## Livestock Plaza/Sheep Barn

Addendum Issue Date: 8/12/24

**A5.1**

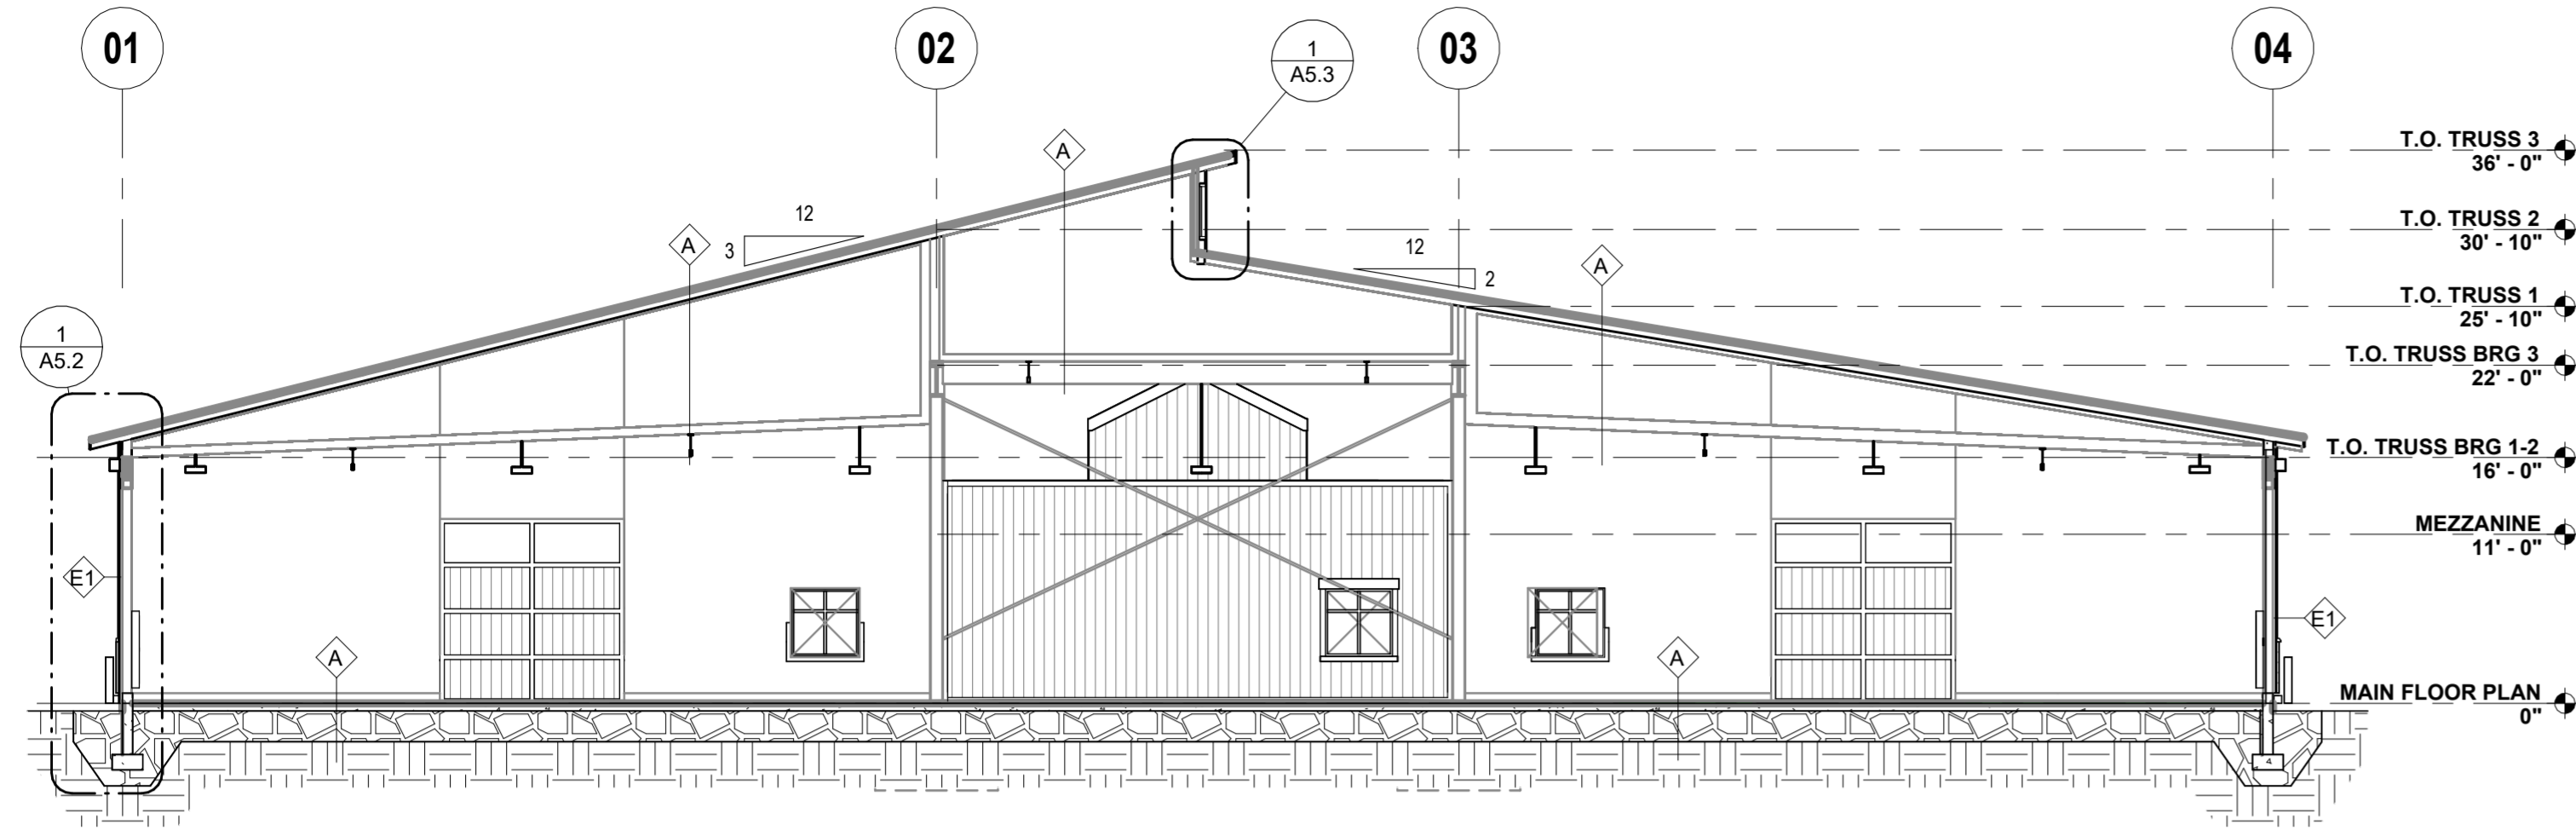
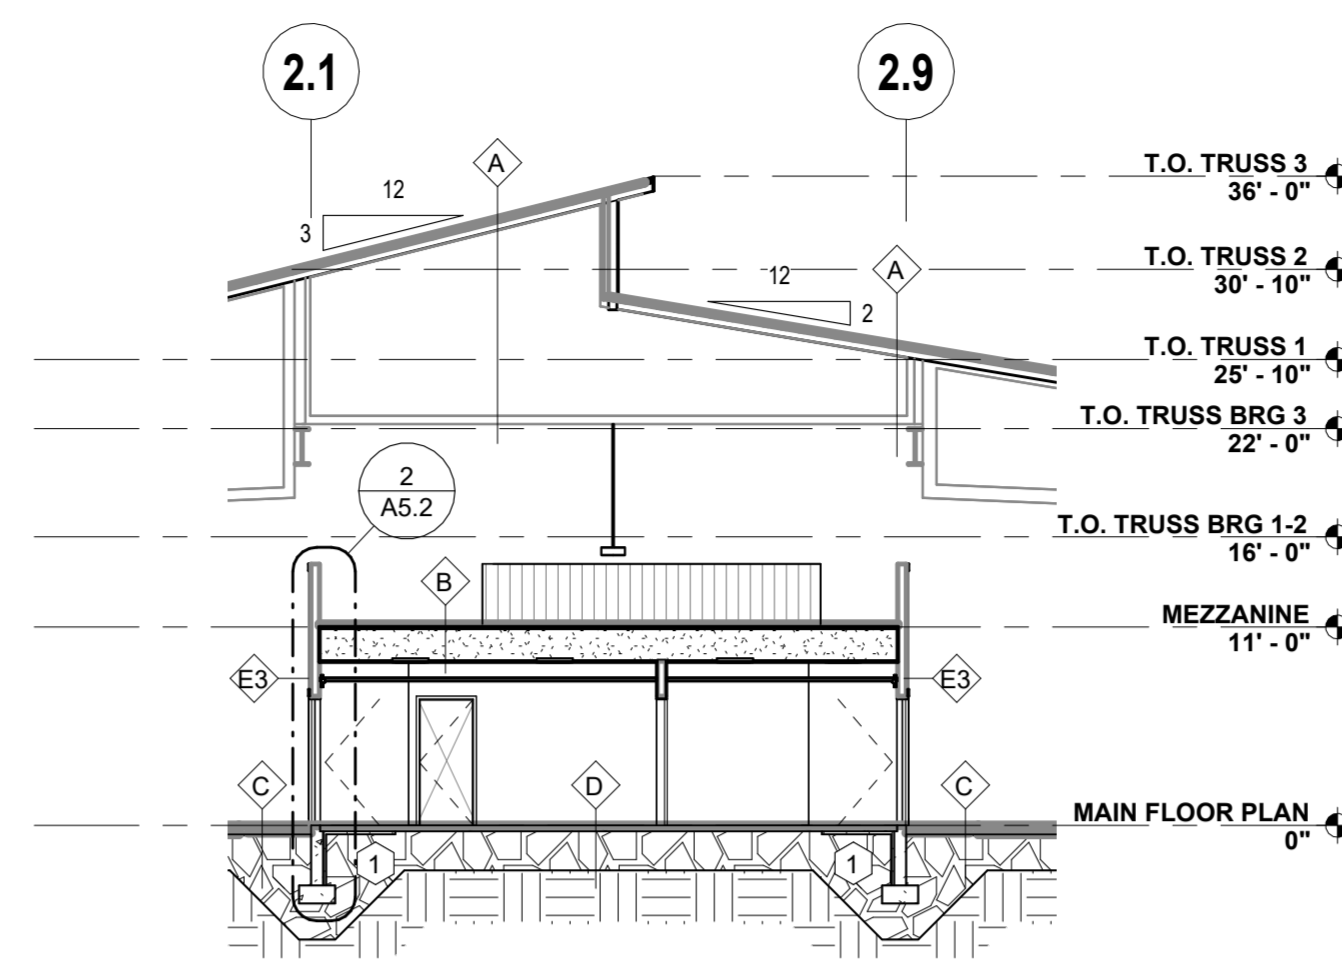
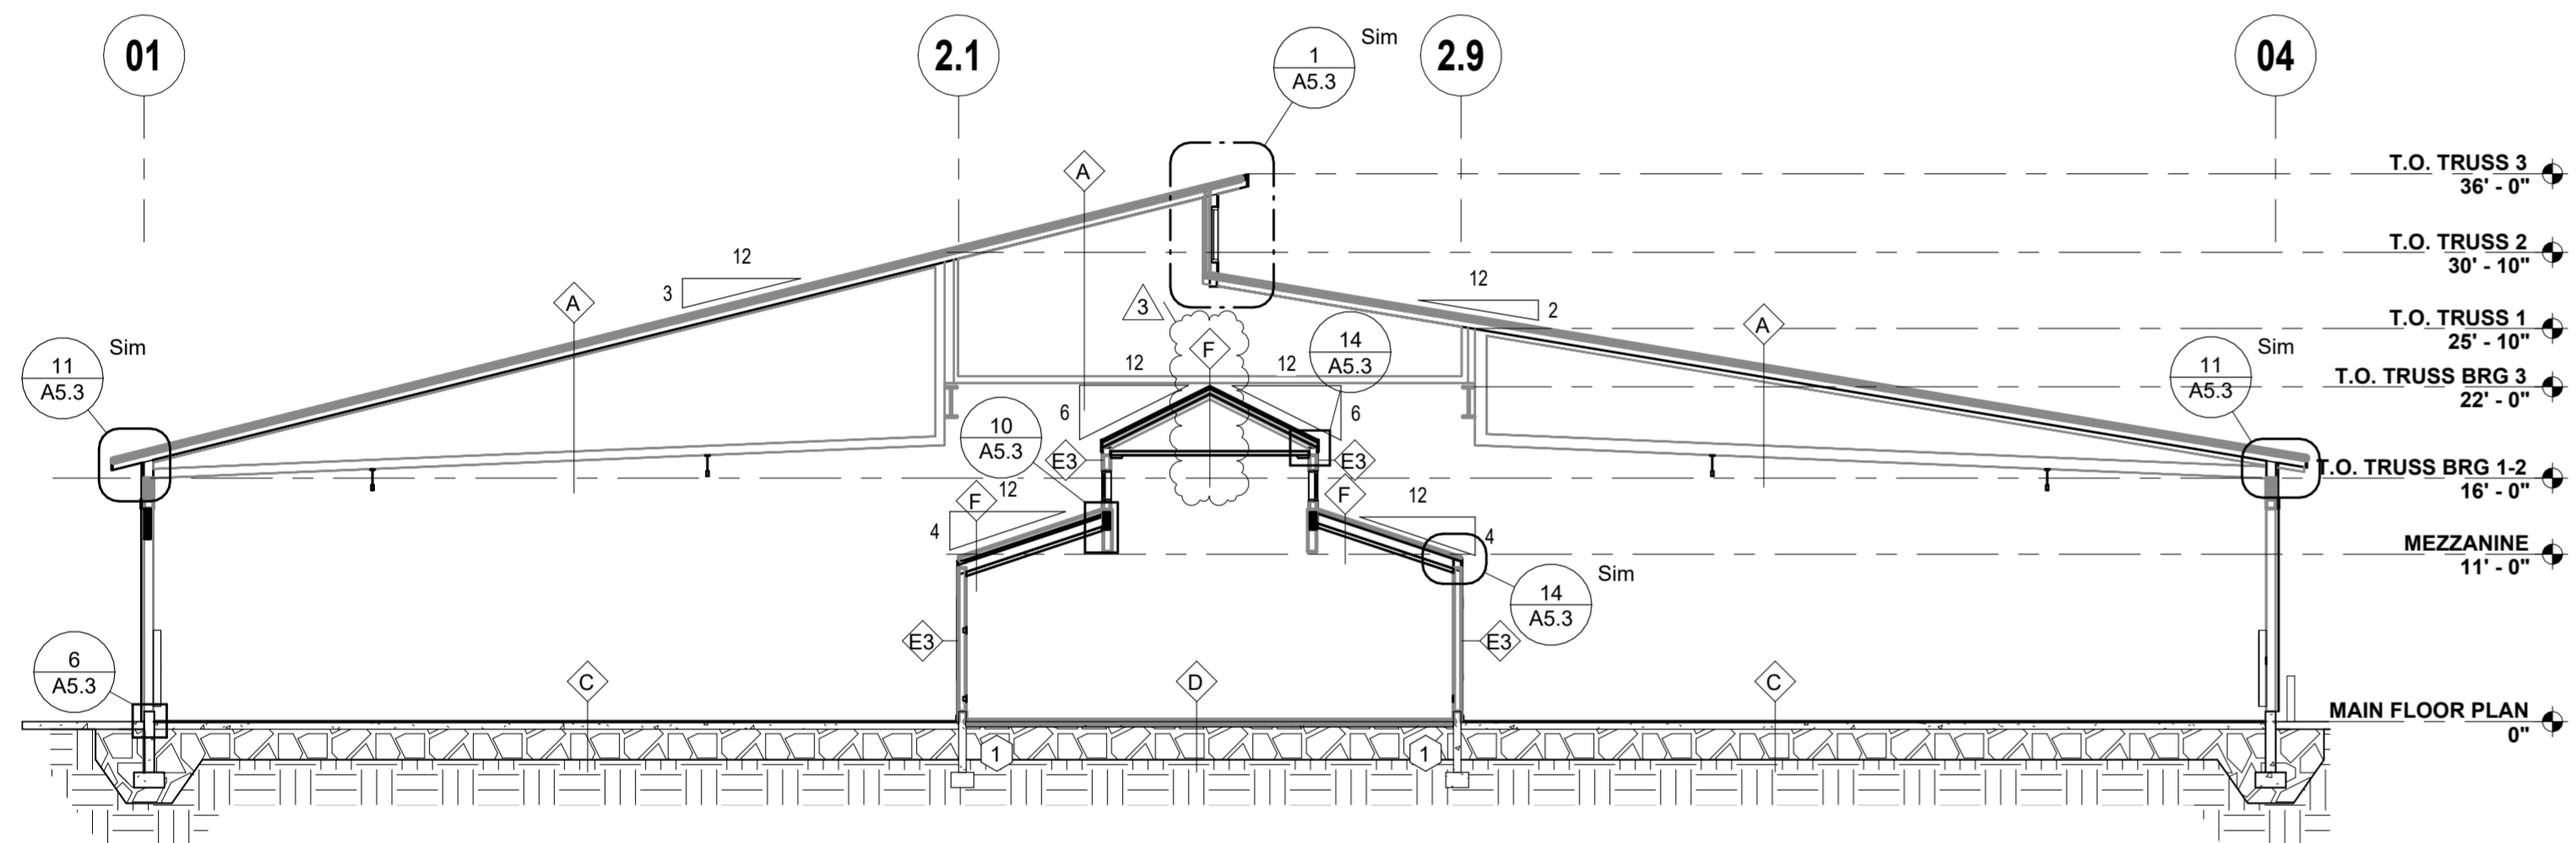
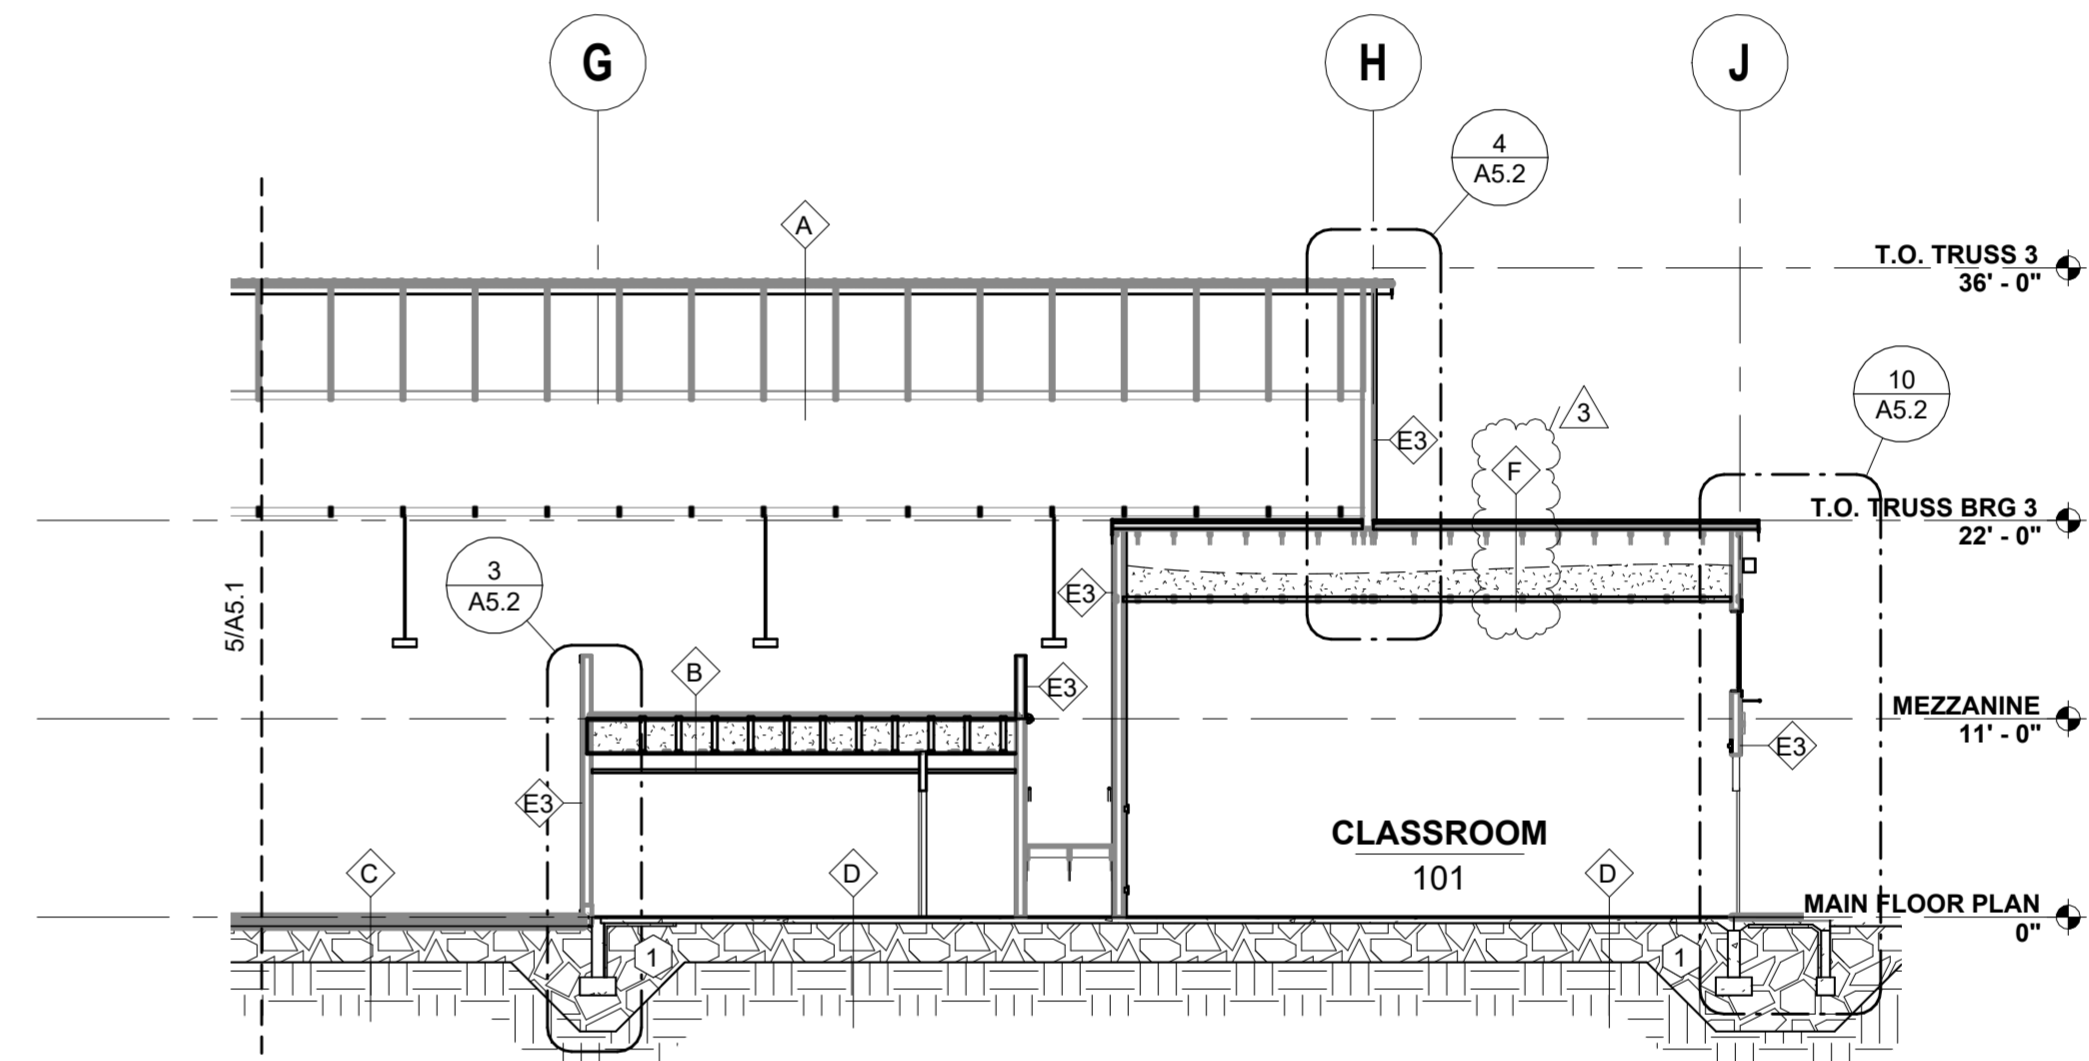
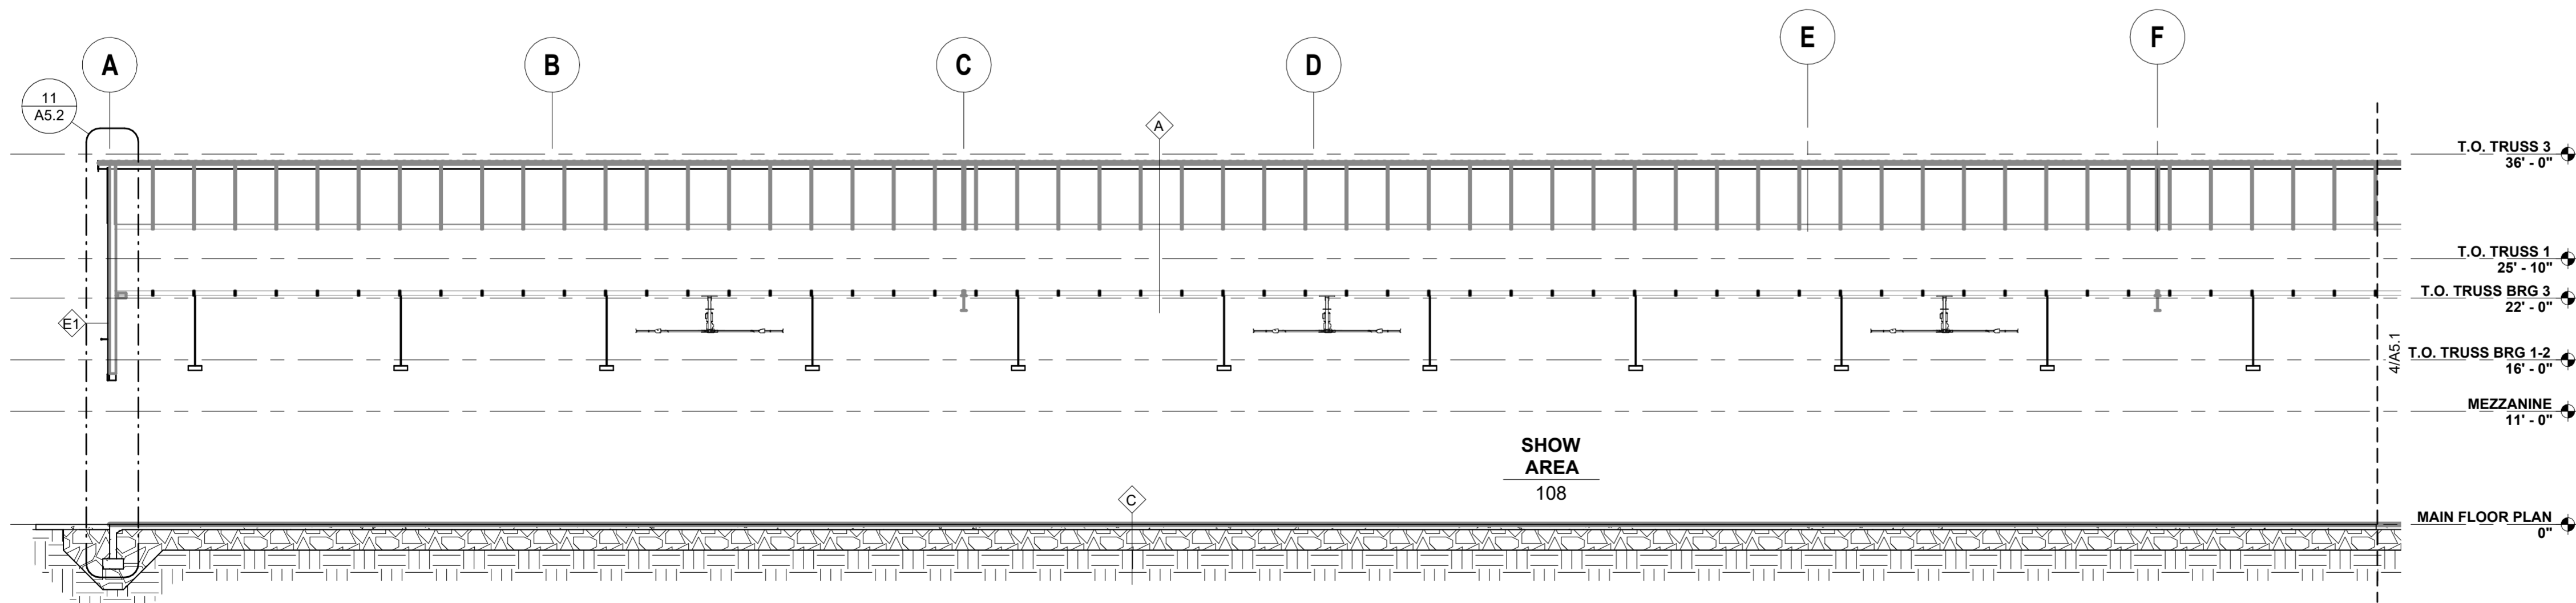
**Sheet A5.1 – Building Sections:**

Roof assembly tags revised.
